SERVICE LETTER

No. 803A

Piper Aircraft Corporation

Subject: Cabin Door Latch System Refinement

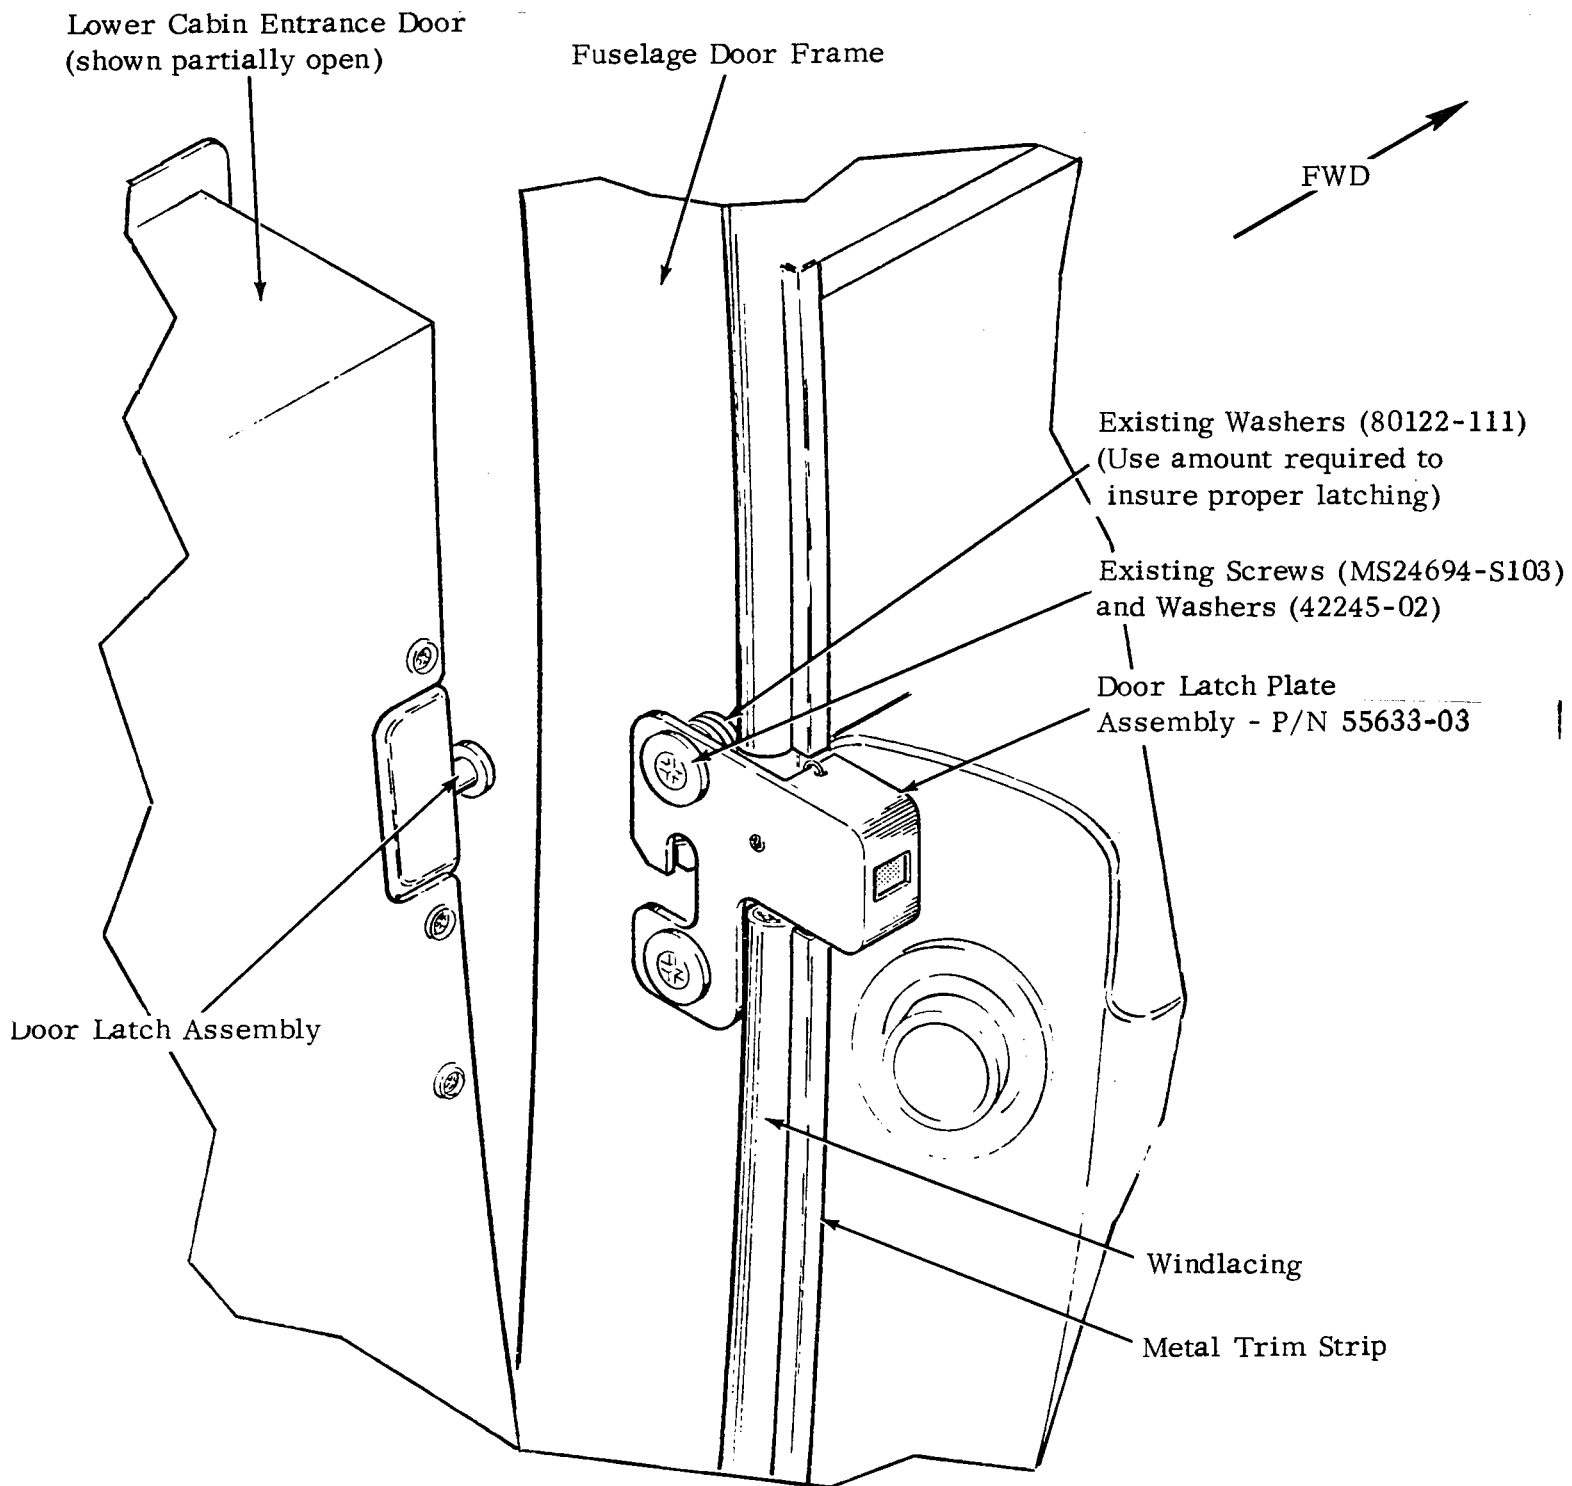
It has been found that the adhesive substance (attaches the "SAFE" flag to its mating surface) may deteriorate, allowing the placard to detach. This service release announces availability of new redesigned Door Latch Plate Assembly containing a riveted "SAFE" indicator flag (placard).

Instructions: (1.) Affected aircraft covered by this service release that have not previously complied with Service Letter No. 803, refer to attached sketch instruction data for Door Latch Plate Assembly, Piper part number 55633-03 installation information.

1. Remove existing forward door latch plate from fuselage door frame.
2. Install new door latch plate assembly P/N 55633-03 using existing screws and washers. Cut windlacing and metal trim strip, as required, to allow the plate assembly to be properly installed as shown.
3. Close lower door and check to insure that the door latch assembly is completely engaged in the notch of the door latch plate assembly. Adjust as required.
4. Make proper Logbook entry of Service Letter compliance.
